Browns Summit Creek Restoration Project Year 4 Monitoring Report

DMS Project ID No. 96313, DEQ Contract No. 5792

Subject: Response to Task 10 Draft Year 4 Monitoring Report Comments for Browns Summit
(DMS #96313) Cape Fear River Basin; CU 03030002; Guilford County, North
Carolina Contract No. 005792

Figure 4.1
Current Conditions
Plan View
Browns Summit Site
(DMS #96313)

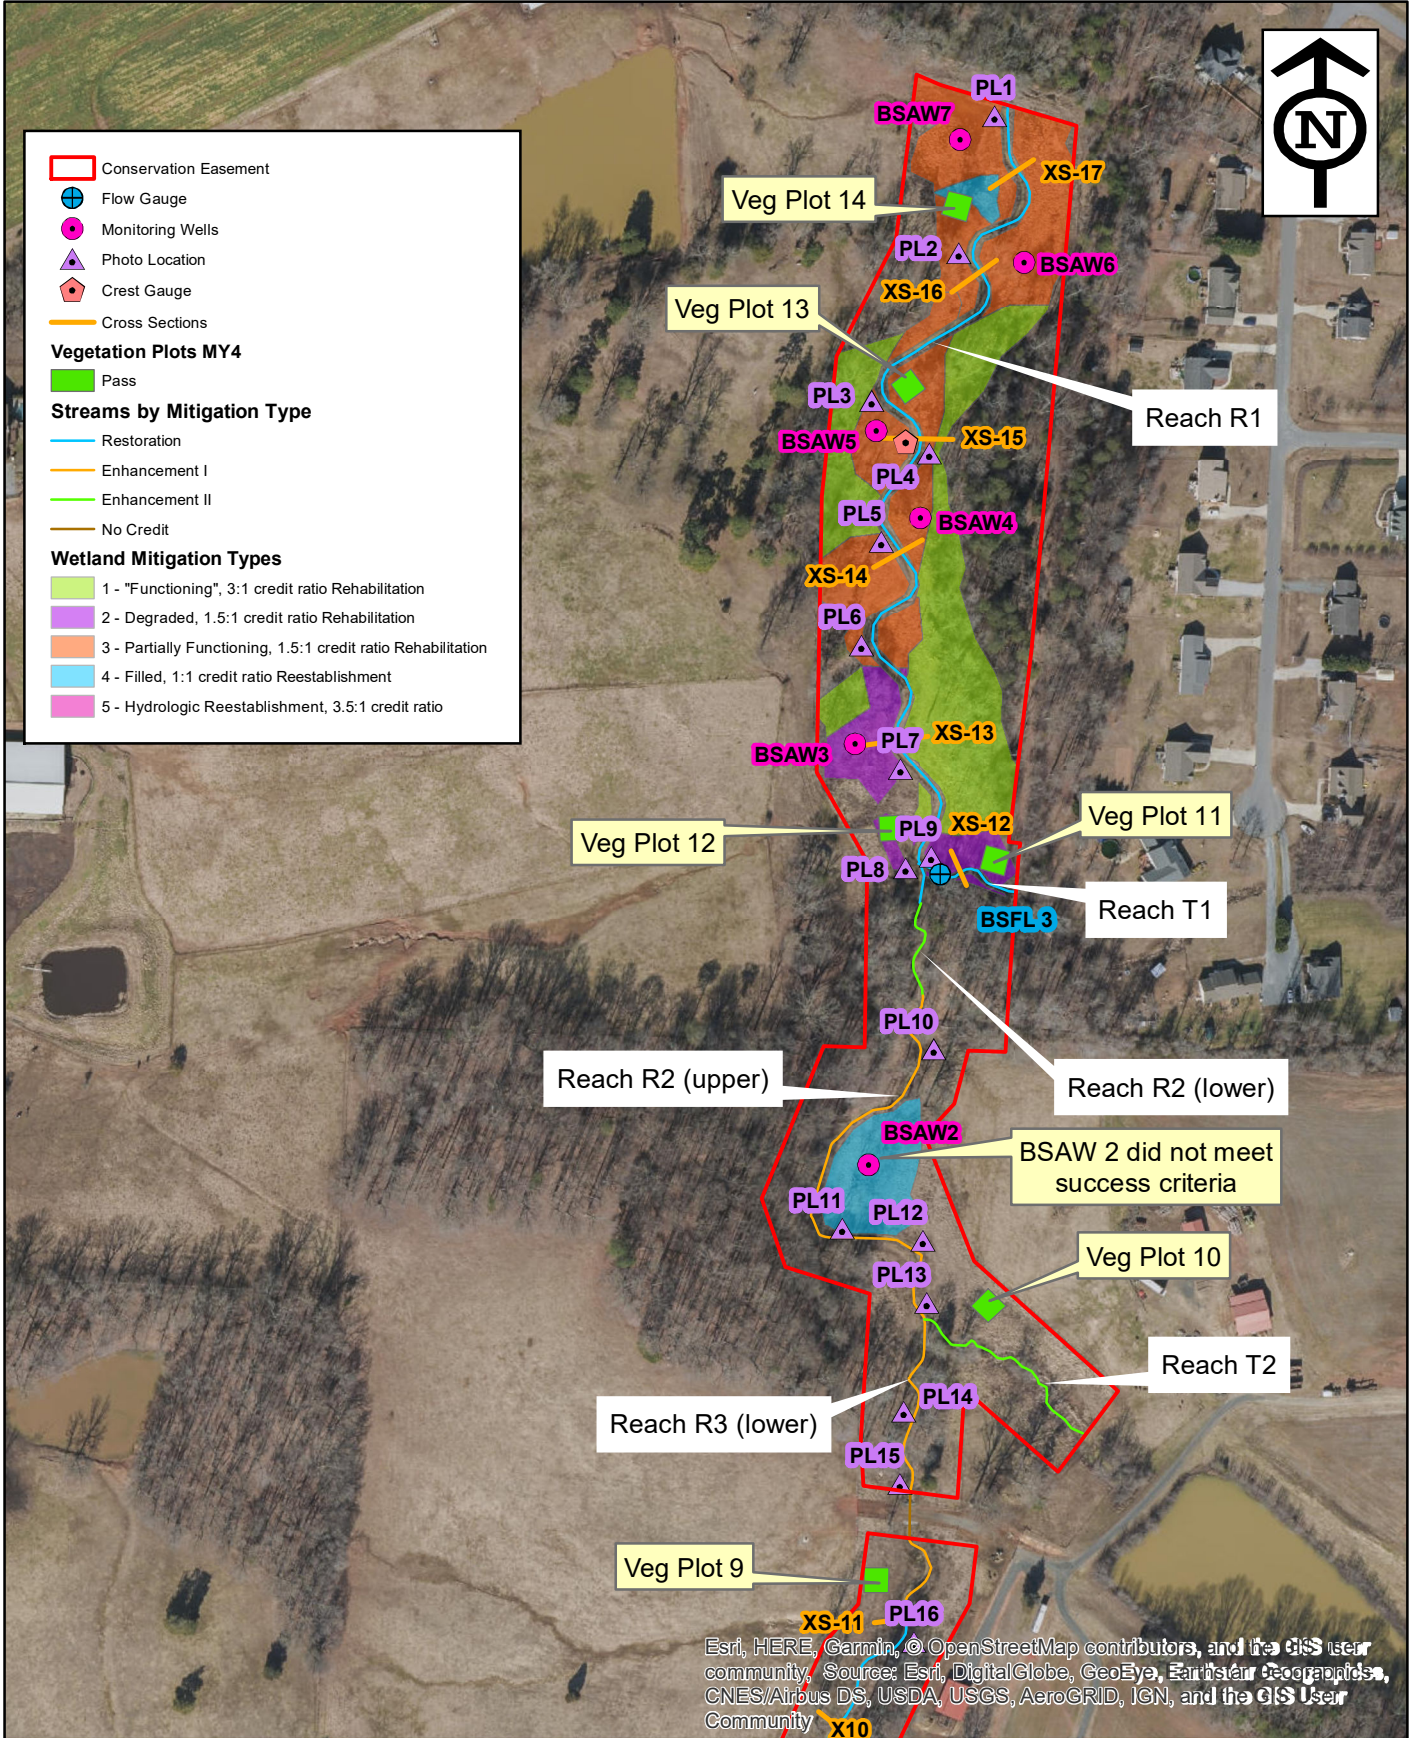
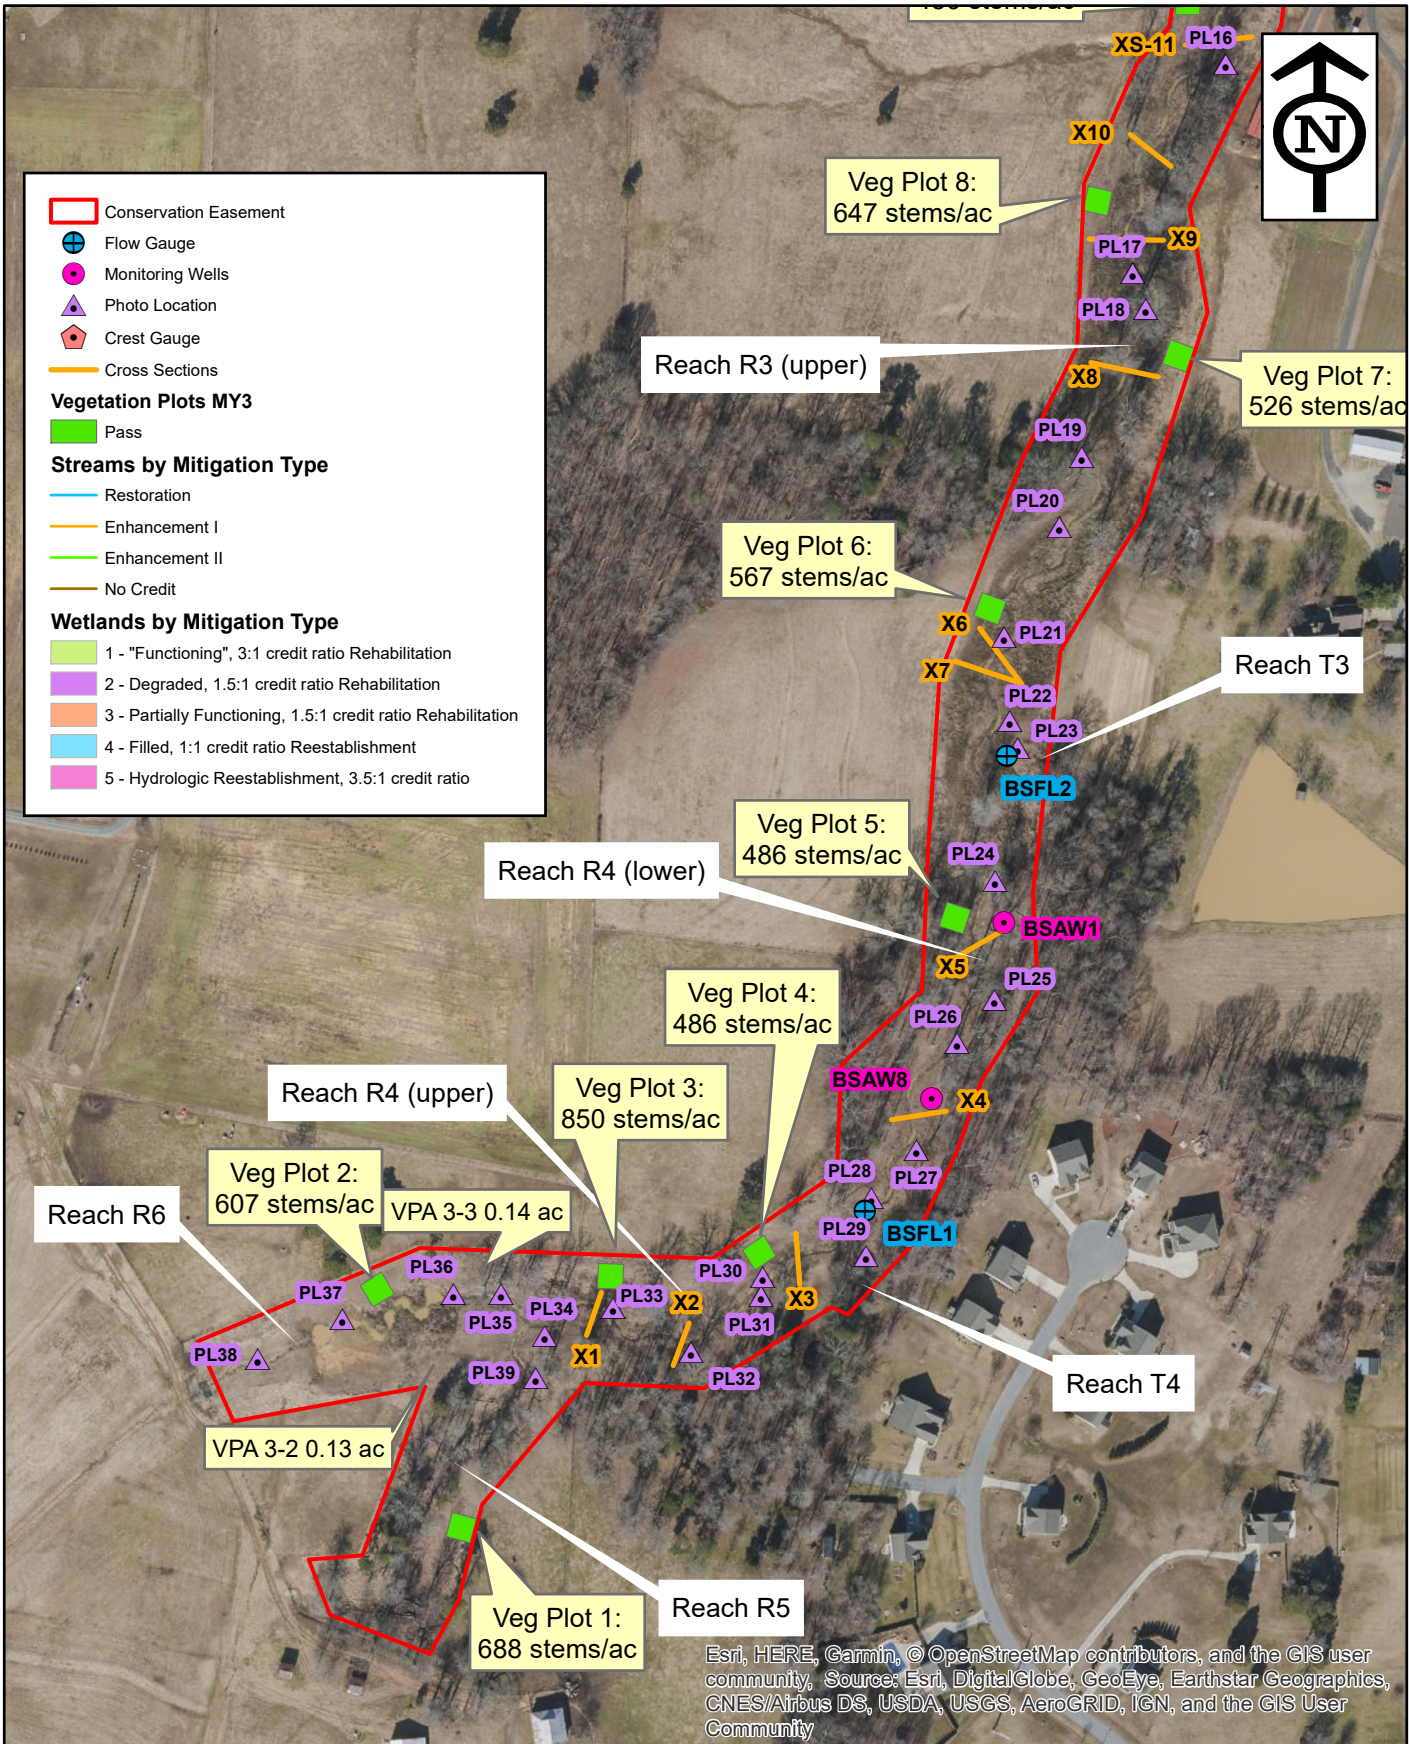
Comment: *Section 1.0 Executive Summary: The report indicates well BSAW8 was installed during MY4 in an adjacent wetland. Please include the location of this well on a figure and provide an interpretation of the data relative to the site.*

Comment: *Appendix A - CCPV: Indicate the location of the Reach 2 structure of concern on the CCPV.*

Comment: *Please spatially identify the area experiencing the grade control issue (Table 5) in the CCPV, and include this feature in the digital submission.*

Response: BSAW8 (MW8) has been added to the CCPV along with a written description located in the executive summary.

Response: Reach 2 grade control failed during MY3 but repaired in MY4. Table 5 has been updated to show no structures failing.
